Responses by Chris McGranahan  
LSC Transportation Consultants, Inc.  
September 16, 2025

Re: Red Mountain Ranch  
Eagle, CO  
LSC #240790

# Summary of Comments on RTC-PW Comments\_09\_TrafficStudy.pdf

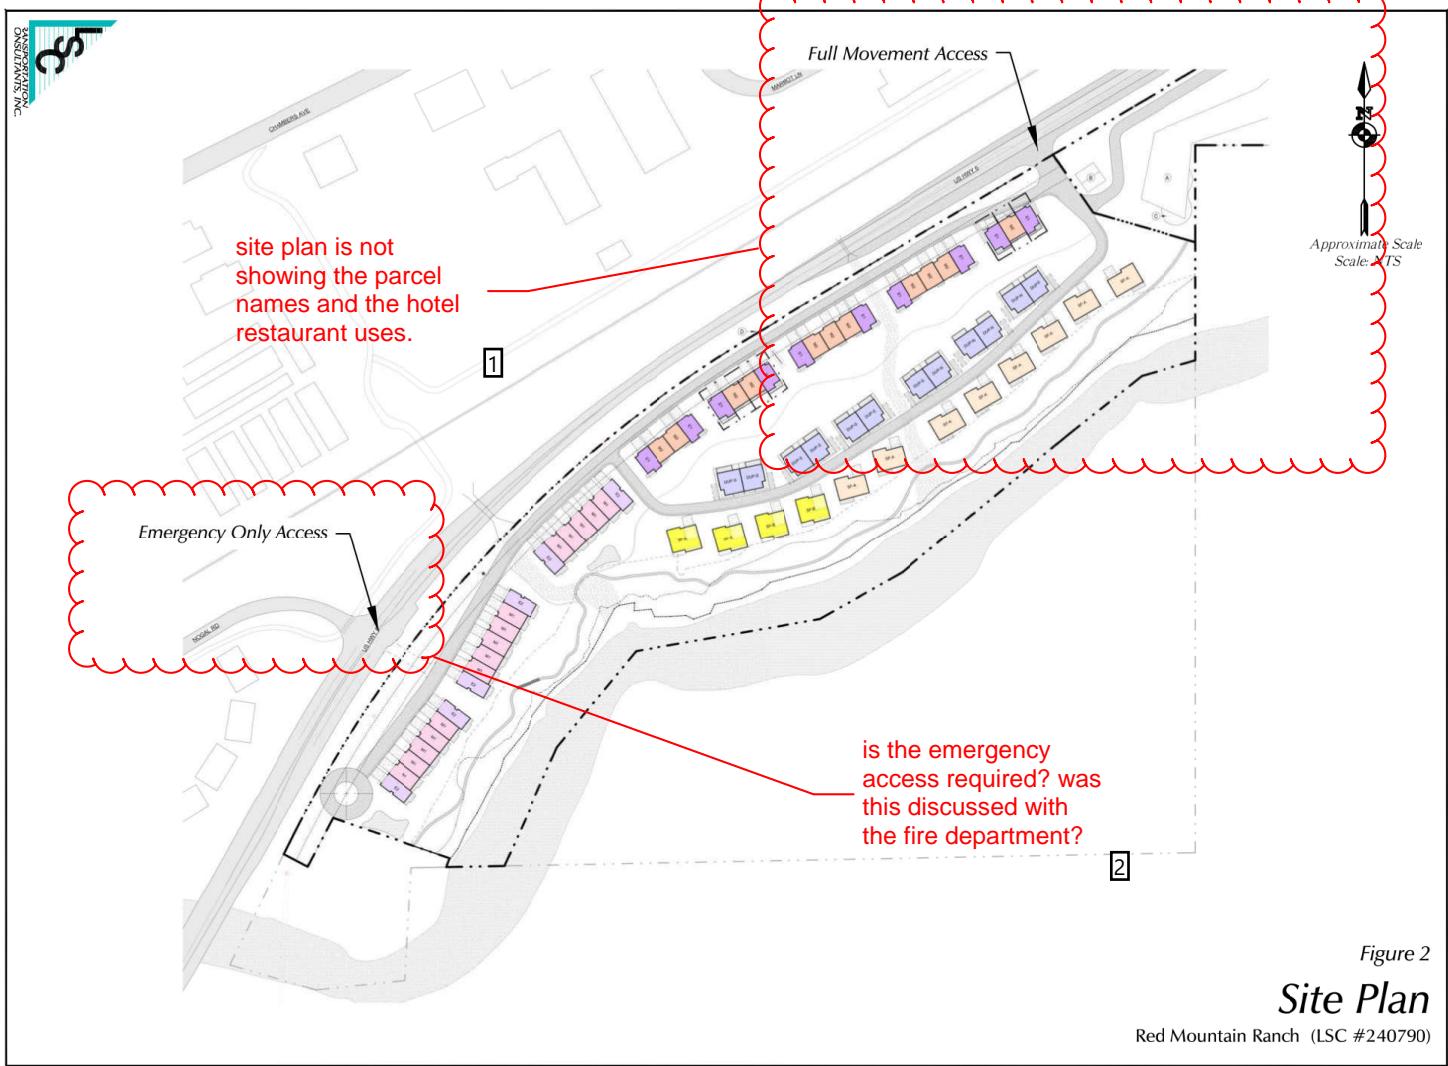
Number: 1 Author: RyanJohnson Subject: Cloud+ Date: 3/27/2025 8:40:18 AM

site plan is not showing the parcel names and the hotel restaurant uses.

Number: 2 Author: RyanJohnson Subject: Cloud+ Date: 3/27/2025 8:40:55 AM

is the emergency access required? was this discussed with the fire department?

Author: lsc Subject: Sticky Note Date: 5/16/2025 11:26:27 AM

The plan has been updated.

Author: lsc Subject: Sticky Note Date: 5/16/2025 11:26:02 AM

The fire department is not requiring emergency access so it has been removed in the updated study.
